BUILDING CODE OF AUSTRALIA COMPLIANCE ASSESSMENT REPORT

Proposed school building

Snowy Mountains Grammar School, Jindabyne

REPORT NO. ► PROJECT 10878 - REV 3.0

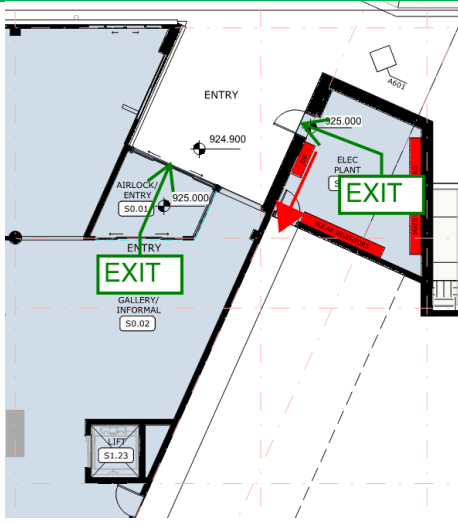
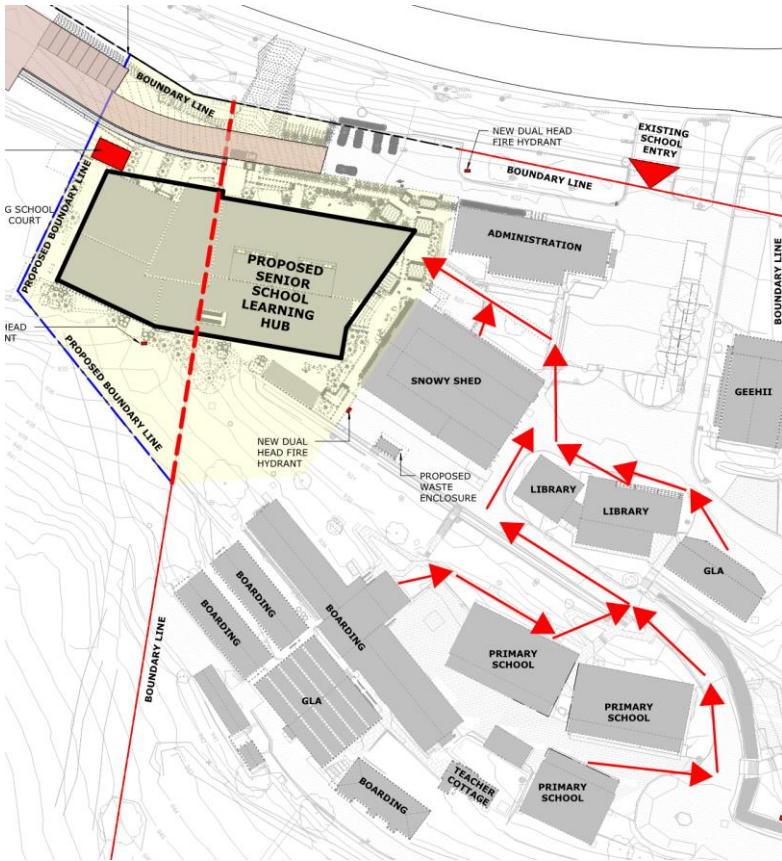
BCA Clause	Deemed-to-Satisfy Provision to be addressed
D1.2 Number of Exits required	<p>Ground Floor</p> <ul style="list-style-type: none"> - Battery room – egress through the Spoon Drain area (red arrow in snapshot below) is required for access to a second access to comply with the DTS provisions. - Comms – only 1 exit is provided from the comms room. <i>It is recommended that this is addressed by a Fire Engineered Performance Solution</i> - Plant & Kiln – only 1 exit is provided from the comms room. <i>It is recommended that this is addressed by a Fire Engineered Performance Solution</i> - Uniform Store & Uniform Shop – only 1 exit is provided from the comms room. <i>It is recommended that this is addressed by a Fire Engineered Performance Solution.</i>  <ul style="list-style-type: none"> - Electrical plant – egress through the Spoon Drain area (red arrow in snapshot below) is required for access to a second access to comply with the DTS provisions.

Ground Floor Exit locations.

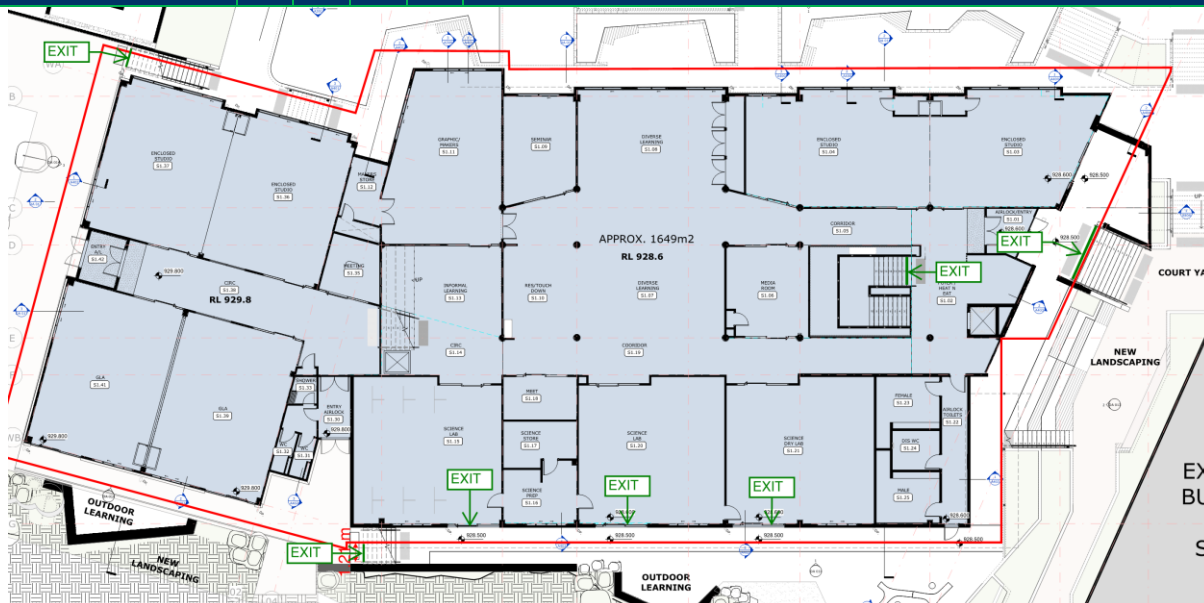
BCA DEEMED-TO-SATISFY PROVISION	COMPLIES	DOES NOT COMPLY	NA or Informational	Compliance Required	COMMENTS
					<p>(g) Access to exits — Without passing through another sole-occupancy unit every occupant of a storey or part of a storey must have access to—</p> <p>(i) an exit; or</p> <p>(ii) at least 2 exits, if 2 or more exits are required.</p> <div><p>Exit means—</p><p>(a) any, or any combination of the following if they provide egress to a road or open space:</p><p>(i) An internal or external stairway.</p><p>(ii) A ramp.</p><p>(iii) A fire-isolated passageway.</p><p>(iv) A doorway opening to a road or open space.</p><p>(b) A horizontal exit or a fire-isolated passageway leading to a horizontal exit.</p><p>Open space means a space on the allotment, or a roof or similar part of a building adequately protected from fire, open to the sky and connected directly with a public road.</p></div> <p>DTS non-compliance</p> <p>Ground Floor</p> <ul style="list-style-type: none">- Battery room – egress through the Spoon Drain area (red arrow in snapshot below) is required for access to a second access to comply with the DTS provisions.- Comms – only 1 exit is provided from the comms room. <i>It is recommended that this is addressed by a Fire Engineered Performance Solution</i>- Plant & Kiln – only 1 exit is provided from the comms room. <i>It is recommended that this is addressed by a Fire Engineered Performance Solution</i>- Uniform Store & Uniform Shop – only 1 exit is provided from the comms room. <i>It is recommended that this is addressed by a Fire Engineered Performance Solution.</i>

First Floor exit locations (red line details roof).

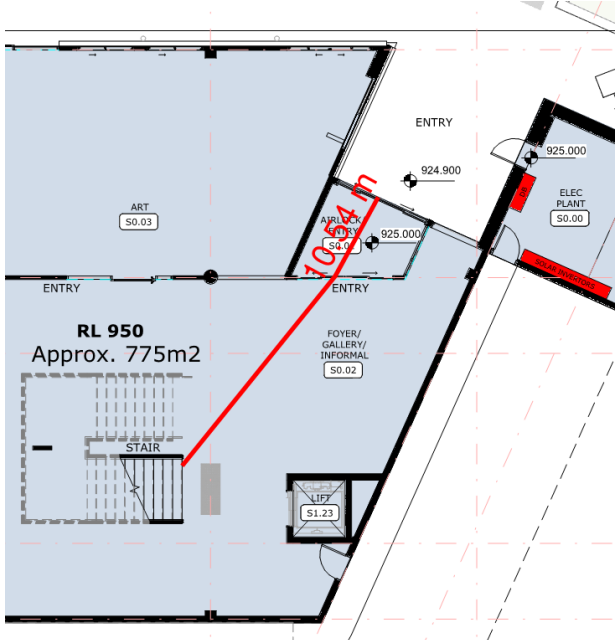
BCA DEEMED-TO-SATISFY PROVISION	COMPLIES	DOES NOT COMPLY	NA or Informational	Compliance Required	COMMENTS
					<p>(f) Assembly buildings — In a Class 9b building other than a school or early childhood centre, the distance to one of the exits may be 60 m if—</p> <ul style="list-style-type: none"> (i) the path of travel from the room concerned to that exit is through another area which is a corridor, hallway, lobby, ramp or other circulation space; and (ii) the room is smoke-separated from the circulation space by construction having an FRL of not less than 60/60/60 with every doorway in that construction protected by a tight fitting, self-closing, solid-core door not less than 35 mm thick; and (iii) the maximum distance of travel does not exceed 40 m within the room and 20 m from the doorway to the room through the circulation space to the exit. <p>- Ground Level travel distance calculations (DTS compliant)</p>  <p>- First Floor travel distance calculations (DTS compliant)</p>

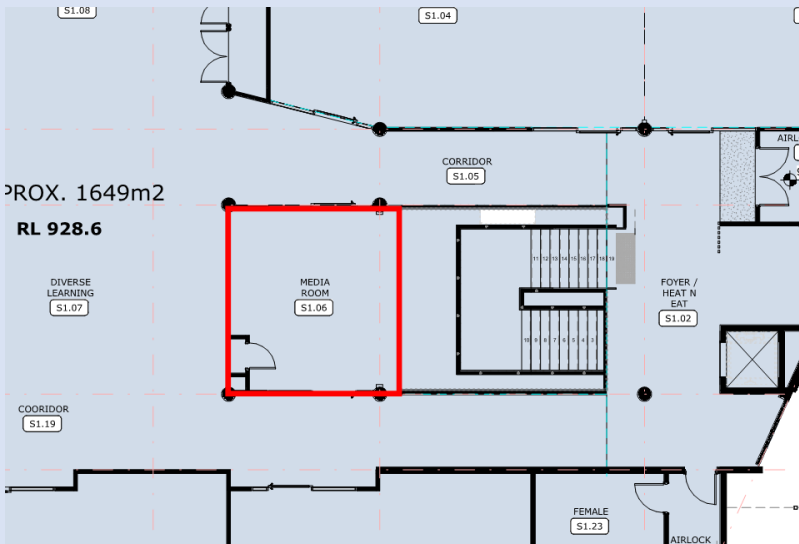
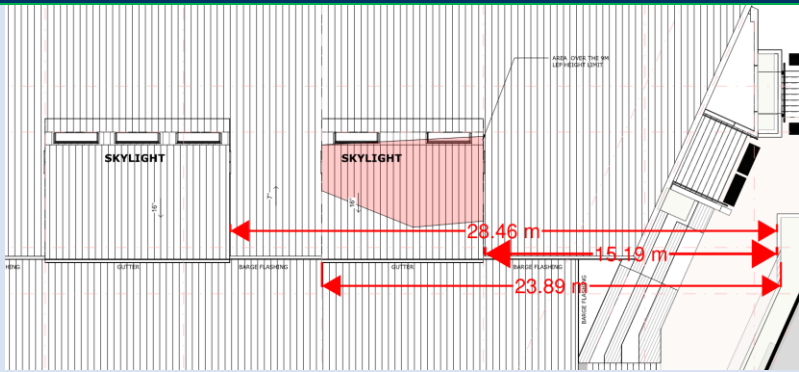
BCA DEEMED-TO-SATISFY PROVISION	COMPLIES	DOES NOT COMPLY	NA or Informational	Compliance Required	COMMENTS
Methods and extent of natural lighting					<p>(i) windows, excluding roof lights, that—</p> <p class="list-item-l1">(A) have an aggregate light transmitting area measured exclusive of framing members, glazing bars or other obstructions of not less than 10% of the floor area of the room; and</p> <p class="list-item-l1">(B) are open to the sky or face a court or other space open to the sky or an open verandah, carport or the like; or</p> <p>(ii) roof lights, that—</p> <p class="list-item-l1">(A) have an aggregate light transmitting area measured exclusive of framing members, glazing bars or other obstructions of not less than 3% of the floor area of the room; and</p> <p class="list-item-l1">(B) are open to the sky; or</p> <p>(iii) a proportional combination of windows and roof lights required by (i) and (ii).</p> <p>(b) In a Class 9 building a required window that faces a boundary of an adjoining allotment or a wall of the same building or another building on the allotment must not be less than a horizontal distance from that boundary or wall that is the greater of—</p> <p class="list-item-l1">(i) generally — 1 m; and</p> <p class="list-item-l1">(iii) 50% of the square root of the exterior height of the wall in which the window is located, measured in metres from its sill.</p> <p><u>DTS non-compliance</u></p> <p>Ground – The Design Tech room is not provided with natural light in accordance with this clause.</p> <p>Please note borrowed natural light under F4.3 cannot be applied to Class 9b buildings.</p> <p><i>It is recommended this is addressed by a Performance Solution.</i></p>

BCA DEEMED-TO-SATISFY PROVISION	COMPLIES	DOES NOT COMPLY	NA or Informational	Compliance Required	COMMENTS
					 <p>RL 950 Approx. 775m2</p> <p>First Floor – The seminar room is not provided is not provided with natural light in accordance with this clause.</p>  <p>APPROX. 1649m2 RL 928.6</p> <p>Please note the skylights are not provided to provide direct natural light to the Media Room and as borrowed light cannot be applied to Class 9b rooms, it is a DTS non-compliance.</p> <p><i>It is recommended this is addressed by a Performance Solution.</i></p>
